**NATIONAL RAILROAD PASSENGER CORPORATION
NORTHEAST CORRIDOR
NEW YORK - WASHINGTON
SUMMARY BULLETIN ORDER No. NYW1-30SUM
Effective 12:01 AM, Monday, July 6, 2026**

INDEX OF RULE / SI CHANGES OR MODIFICATIONS CONTAINED IN THIS BULLETIN ORDER

3. Switches

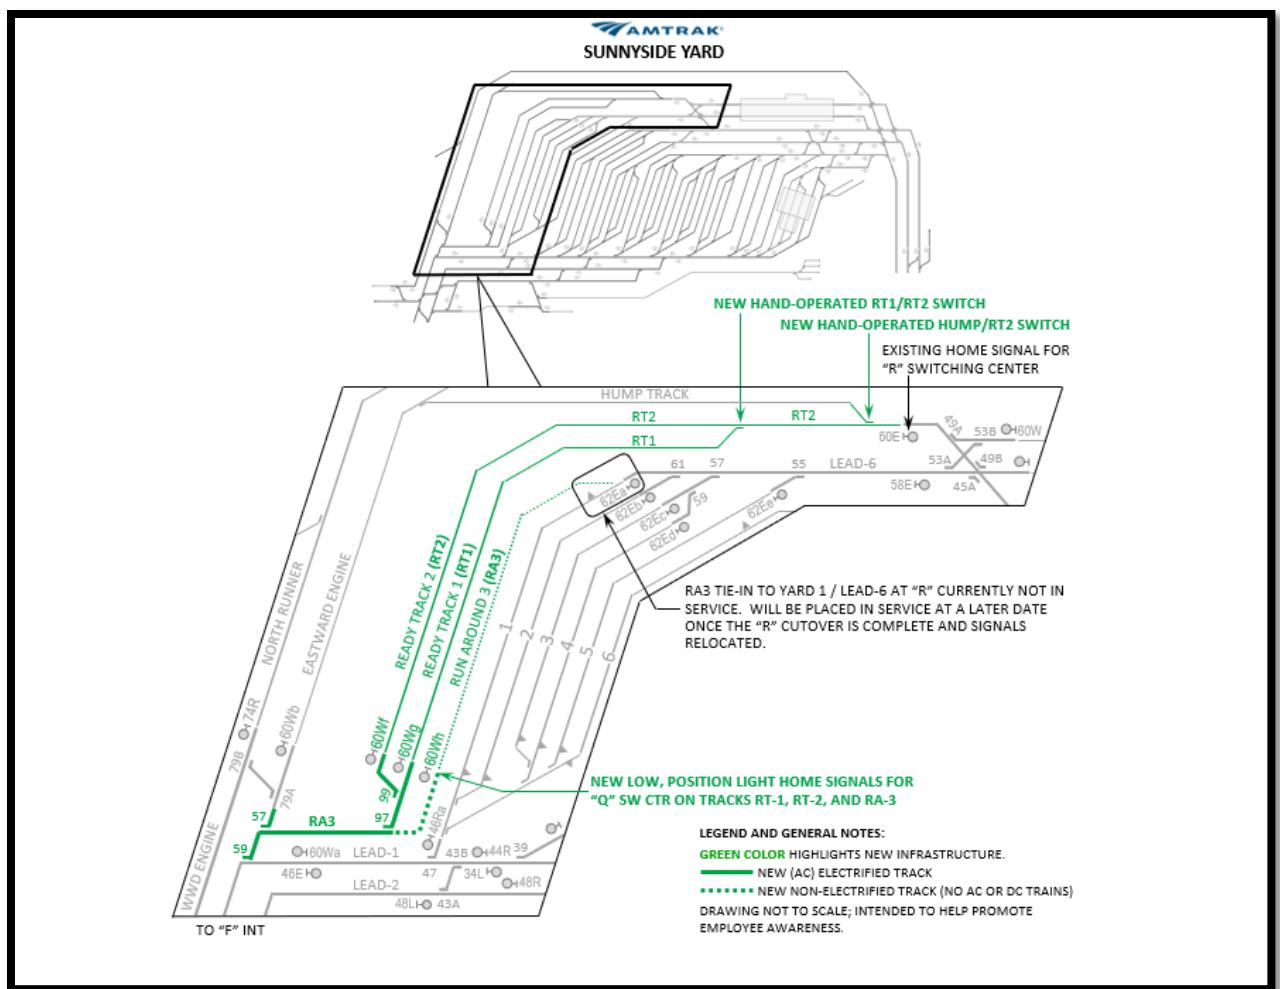
- The No. 97 Switch is installed 490 feet east of the No. 59 switch at Q Switching Center.
- The No. 99 Switch is installed 535 feet east of the No. 59 switch at Q Switching Center.

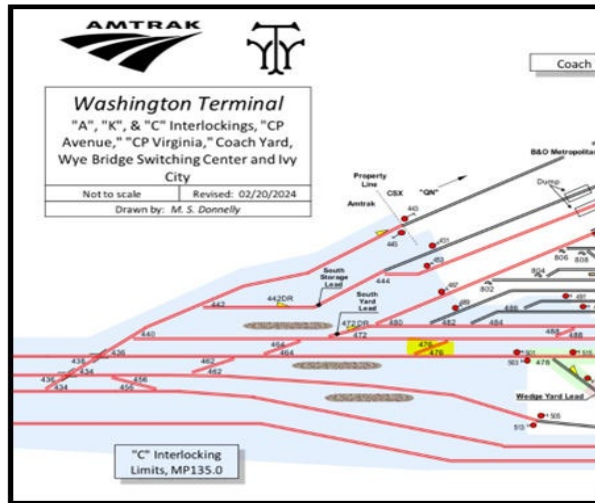
594-W1 is replaced in its entirety.

The following tasks must be performed when entering PTC Track from Non-PTC Track:

- Train should be located within 1,500 feet of main track authority limit or signal governing movement onto PTC track
- Operating at 15 MPH or less
- Select current track location (Unless otherwise restricted, train speed may be increased immediately after track selection)

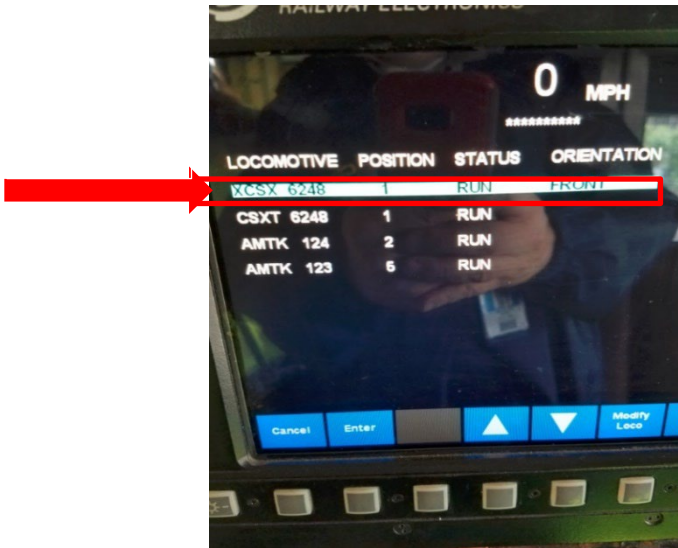
- d) When initializing PTC on a Foreign Locomotive, the Consist Summary will contain an extra locomotive, identified with an “X” leading the locomotive reporting mark. This is reflected in the Locomotives menu in the Consist Summary (examples below). The locomotive with an “X” leading the reporting mark must be removed from the Locomotive Consist on the PTC display. Additional consist modification is not required when removing a locomotive from the Consist Summary.

(See photos for removal of duplicated locomotives below)
